STAFF RECOMMENDATION

1515 Holly Street

Application: New Construction—Addition

Description of Project: The applicant proposes to alter the roof and upperstory of an existing rear addition to an historic house. The addition is wider than the historic house, and the new roof will be taller than the historic house.

ROOF PLAN

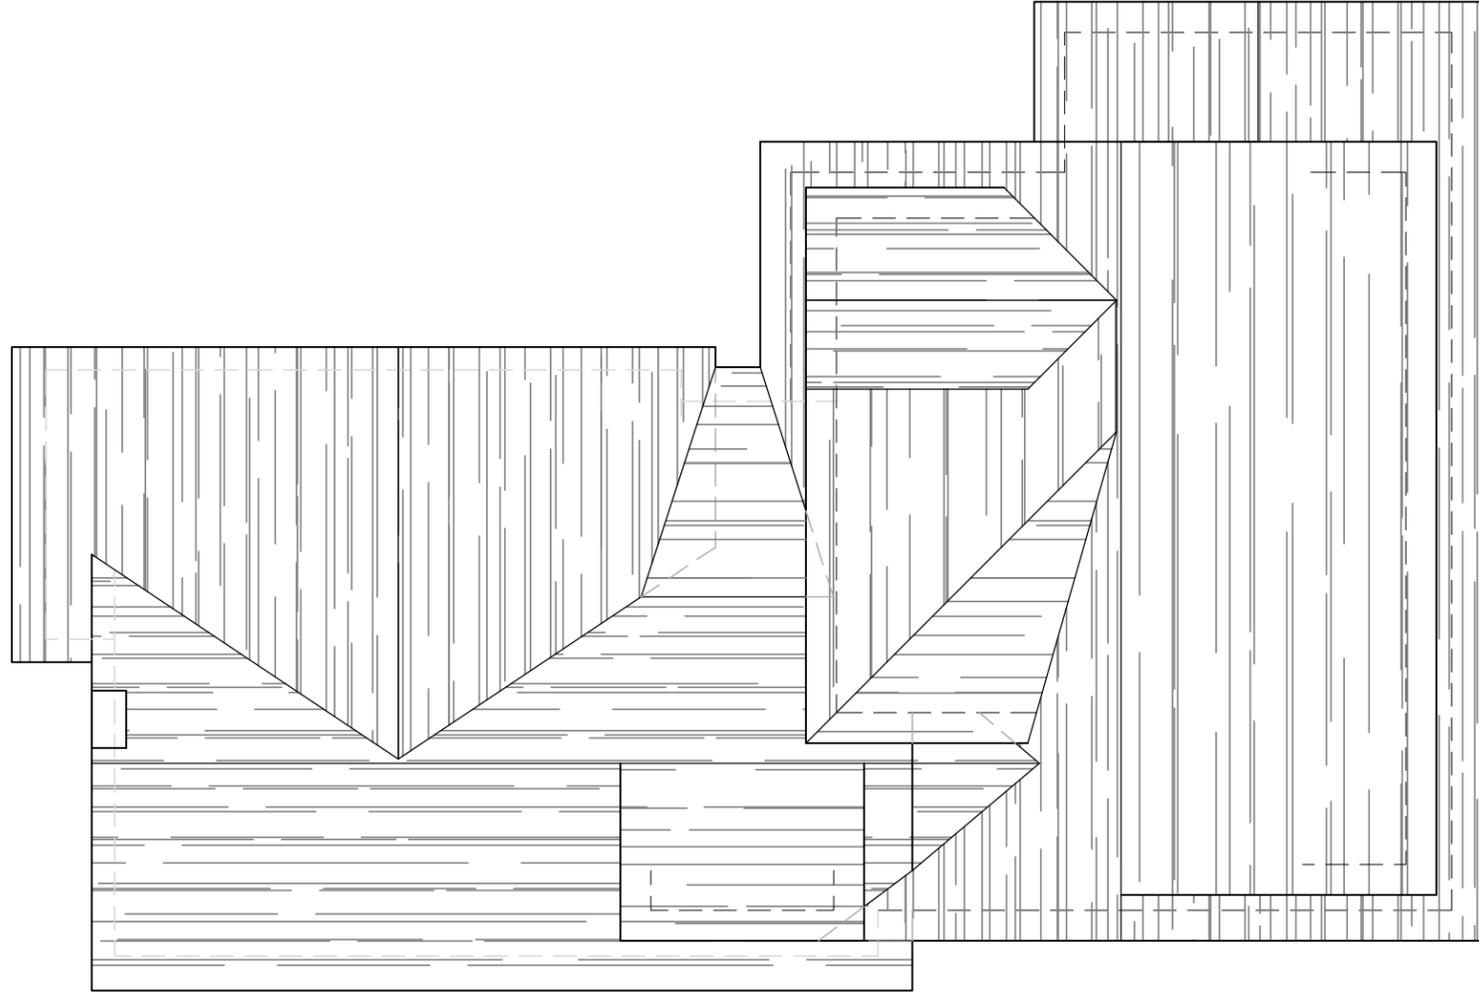
Location & Removability: The new roof will attach to the reconstructed original roof at the rear, in much the same way as before, stepped in one foot (1') from the right side and tying into the rear wing of the original roof that is obscured behind the side-facing gable on the left.

A new shed dormer will be added on the right side of the reconstructed original roof, near the rear. The dormer will tie into the roof ridge, will be eight feet (8') wide, and will be stepped two feet (2') back from the first-story wall below, as is typical of dormers historically. Appropriately scaled dormers are permitted at or beyond the mid-point on the sides of an historic house.

There will also be a shed dormer on the rear slope of the addition, stepped in two feet (2') from the sides of the primary side-gabled roof. Staff finds this dormer to also be appropriate.

Height & Scale: The roof on the addition currently has a side-gabled primary component with a secondary shed component facing the front. The roof will be replaced with a simpler side-gable only form, with a new ridge height that is two feet, four and one-half inches (2'-4 1/2") taller than the original roof.

The footprint of the 2004 addition is not changing, but it is eighteen feet (18') wider and it is generally not appropriate for additions to be both wider and taller than an historic house. Staff finds that increasing the height to be also taller may be appropriate here for three reasons:

Firstly, the original house is extremely small at only twenty-two feet (22') wide and thirty-six feet (36') deep, at only one story with a ridge height of twenty-one feet (21').

Secondly, matching the original 8/12 pitch would generally be appropriate, but with the existing footprint this will result in the addition being one foot (1') taller than the original roof. The proposed slightly different pitch of 9/12 is not noticeably steeper, and the one foot (1') of extra height will not be perceptible from the street.

Roof form: The new side-gable will have a pitch of 9/12, which is slightly steeper than the 8/12 pitch on the original house. This roof will have a gabled dormer on the front. The dormer will be seven feet (7') wide, stepped down one foot (1') off the ridge, and will be stepped two feet (2') back from the wall below.

The gabled roof of the dormer addition will also have a 9/12 pitch, and the shed dormer on the right side of the reconstructed original roof will have a 3/12 pitch. The new shed dormer on the rear will have a 2.25/12 pitch, which is lower than that of similar nearby roofs but will not be visible because it is on the rear.

2 SOUTH ELEVATION
SCALE: 1/8"=1'-0"

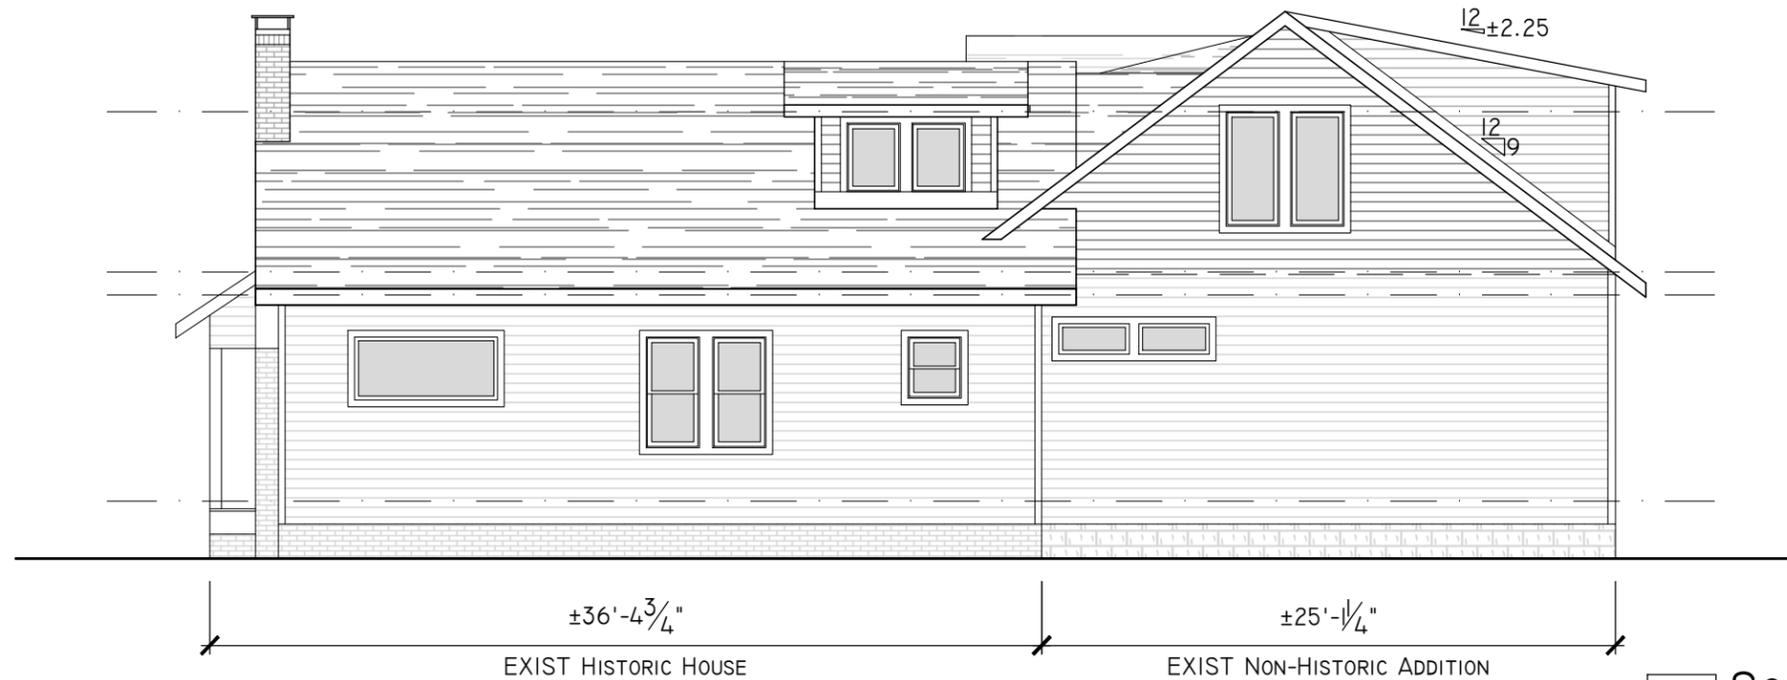
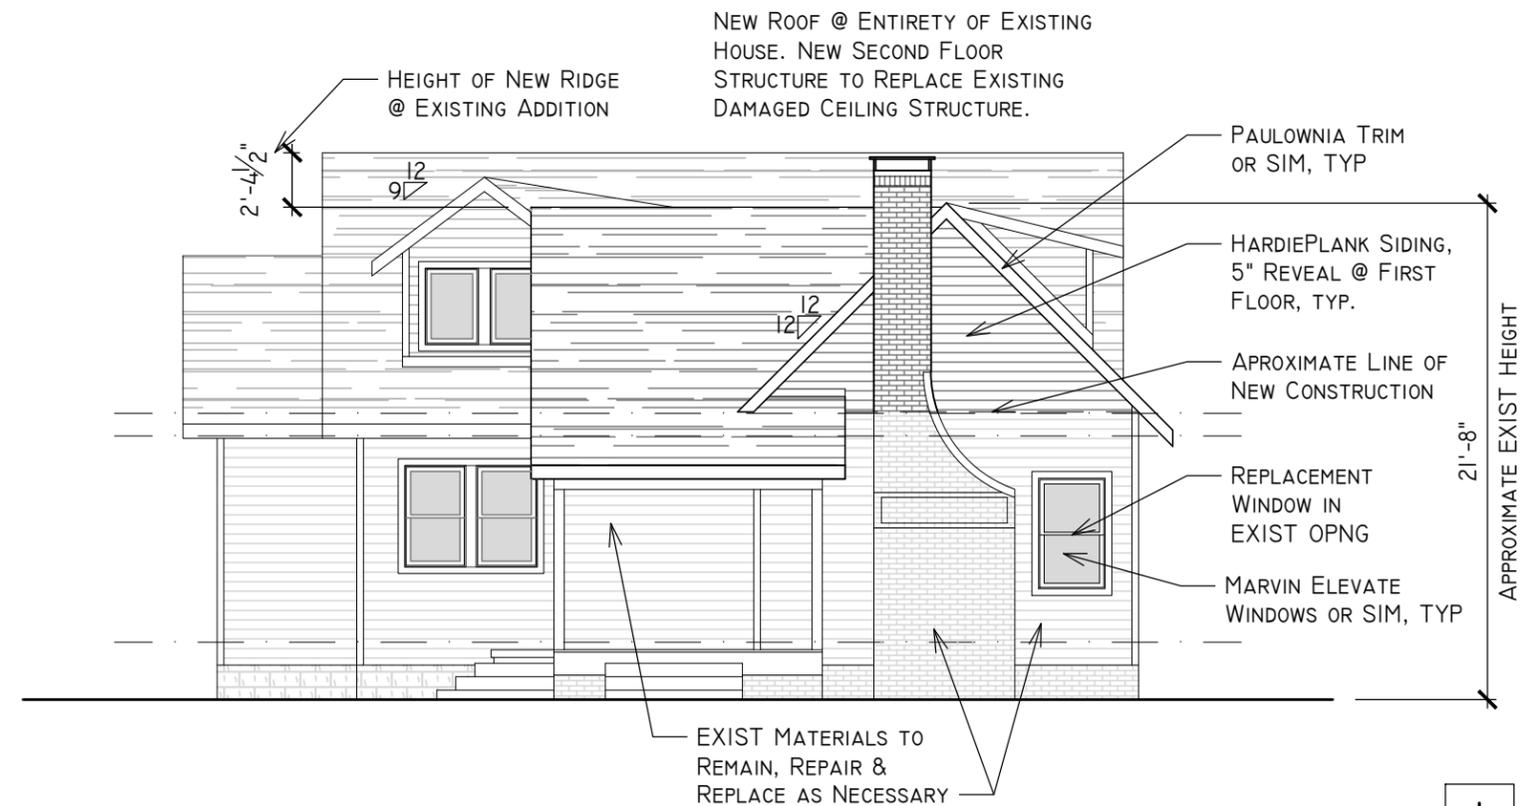
Proportion and Rhythm of Openings: The window openings on the first story of the original house will remain unchanged, but a new window will be added in the left-facing gable in the reconstructed roof. Staff finds that this new window will not impact the character of the house.

Most new windows on the addition will be vertically oriented, with the exception of two pairs of horizontal windows, one on each side of the house. The horizontal windows exist currently on the right side, but on the left side there is currently a pair of taller double-hung windows. Staff finds that the horizontal windows here do not significantly impact the character of the house because they are on the right side currently, and the left side wall is largely obscured by an adjacent contributing

Recommendation: Staff recommends approval of the new roof and upperstory to the existing addition at 1515 Holly Street, with the following conditions:

1. The door selections and roof color shall be approved by MHZC Staff; and,
2. If relocated, the HVAC units shall be located behind the midpoint of the building on a non-street facing façade.
